TO:	Plan Commission
FROM:	Timothy Sobota, Transit Planner, Metro Transit
SUBJECT:	1833 Winnebago Street – Demolition/Rezoning – Kennedy Point Condominiums

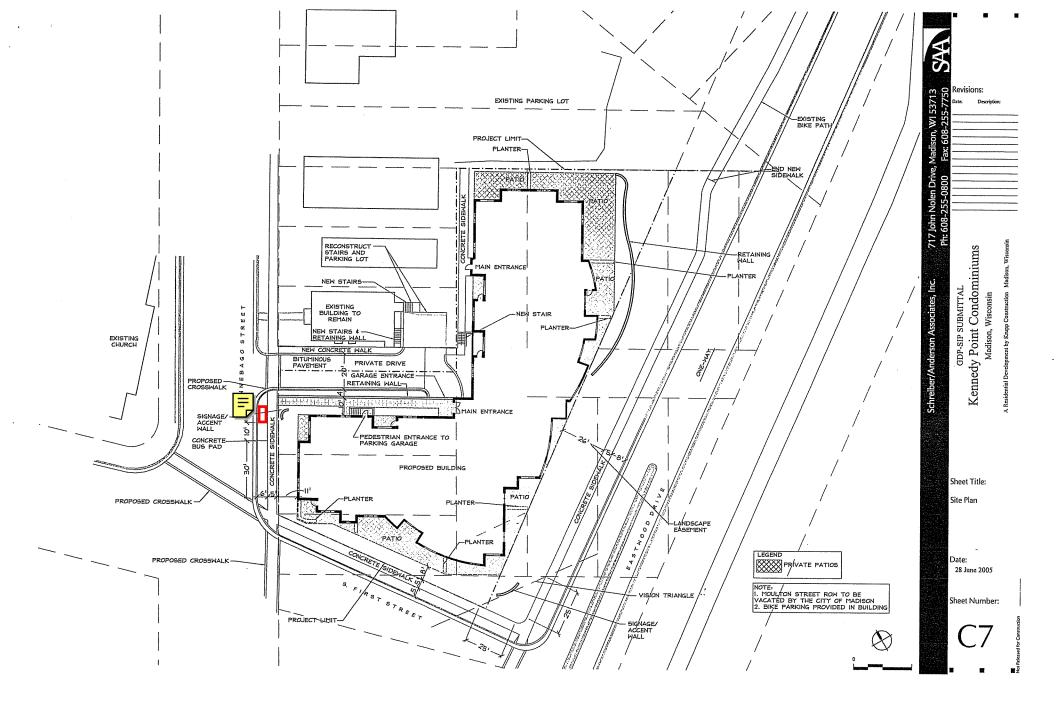
- 1. The applicant shall install a concrete passenger boarding pad on the south side of Winnebago Street, approximately 5 feet west of the corner radius of the private drive. (Approximately ten feet east of location shown on sheet C7 submitted 28 June 2005). The concrete pad shall occupy the full distance of the terrace, measure 10 feet in width parallel to the street, and lie flush between the sidewalk and the top of curb.
- 2. The developer shall revise the location of this concrete passenger boarding pad on the final documents filed with their permit application so that Metro Transit may review and approve the design.
